**ADDENDUM 02 TO BID DOCUMENTS  
FOR  
LIVING SHORELINE DEMONSTRATION PROJECT  
(PO-148)  
ST. BERNARD PARISH, LOUISIANA**

**STATE OF LOUISIANA  
COASTAL PROTECTION AND RESTORATION AUTHORITY**

**OCTOBER 29, 2015**

**The clarifications and revisions in this addendum supersede the requirements in the Bid Documents dated September 2015. The Successful bidder will be issued a complete revised set of plans and specifications.**

**A** SECTION  
CENTER OF WAD  
SCALE IN FEET

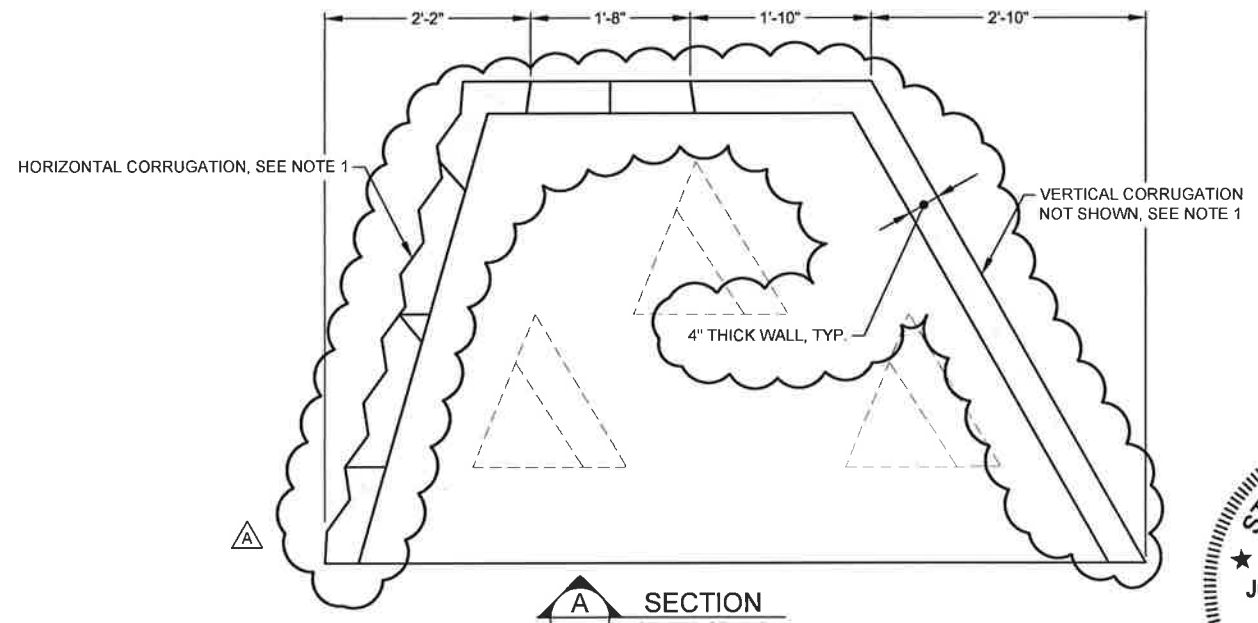
4.1. Sheet 22 – WAD UNIT DETAILS: Wall thickness on Section A modified to 4” thick wall, typical. Revisions are included in Attachment B.

REV.	DATE	DESCRIPTION	BY
A	10/27/15	REVISED WALL THICKNESS	JC

10.5.1.1 WAD units are constructed of 5,000 psi marine grade concrete reinforced with fibermesh, shall have at least three (3) solid walls, approximately ~~6.0~~ **4.0** inches thick. WAD walls shall be either smooth or corrugated as shown on the Plans. Walls on the corrugated WADs shall be horizontally corrugated on one face of the WAD and vertically corrugated on back two side walls, as shown on Plans. Walls are to be tapered with lower portion of the WADs having an approximate 11.0 foot dimension from projected point to projected point (9.5 foot actual base length), rising 5.0 feet in height to a 4.55 foot table. WADs shall have an open bottom and an enclosed top wall with an opening. Side walls shall have triangular tapered openings. WAD units are to be fabricated as detailed on the Plans.

**A** SECTION  
CENTER OF  
OYSTERBREAK  
SCALE IN FEET

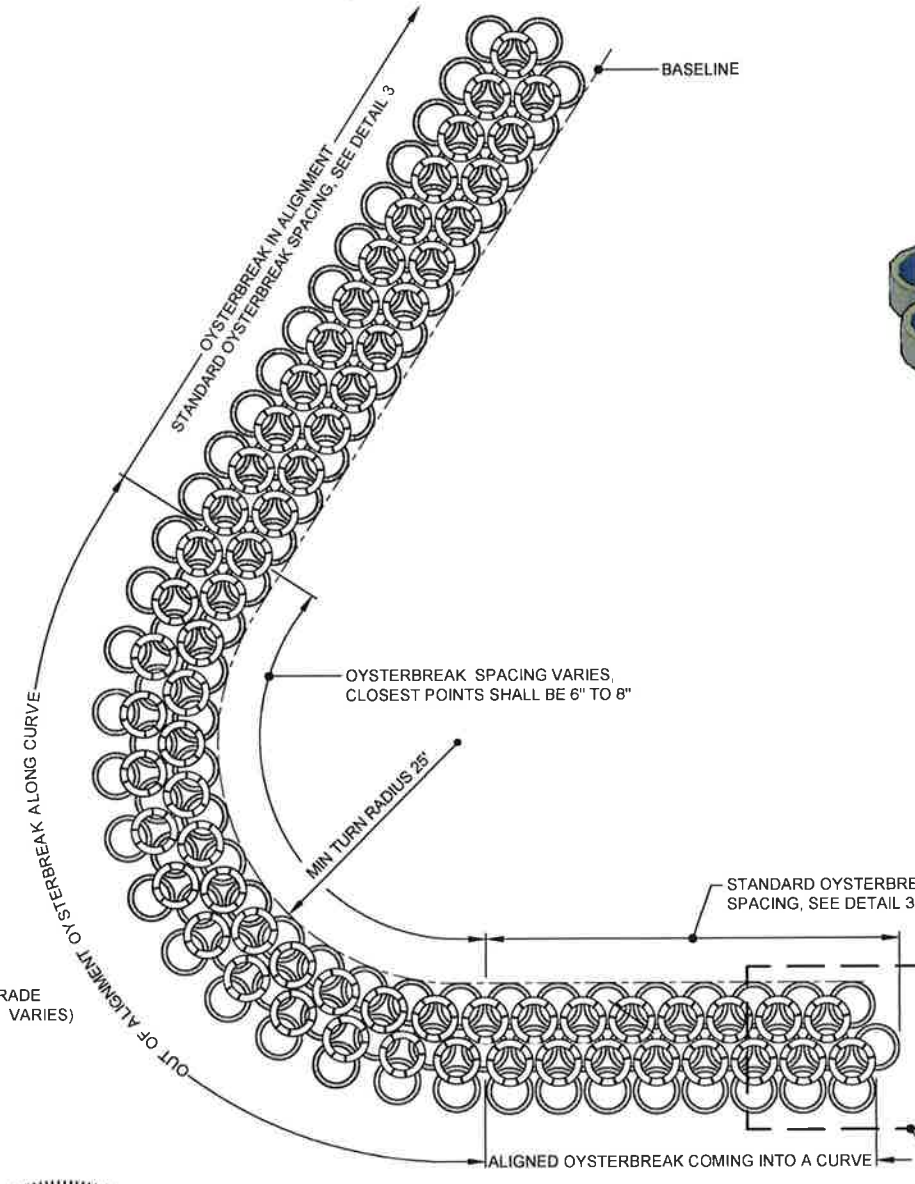
4.2. Sheet 28 – OYSTERBREAK LAYOUT: Section A is mirrored to show two pegs of the top Oysterbreak units facing seaward to match Detail 1, and Detail 3 is modified to show revised Oysterbreak spacings. Revisions are included in Attachment B.

REV.	DATE	DESCRIPTION	BY
A	10/23/15	REVISED TOP LAYER ORIENTATION; REVISED UNIT SPACING	JC
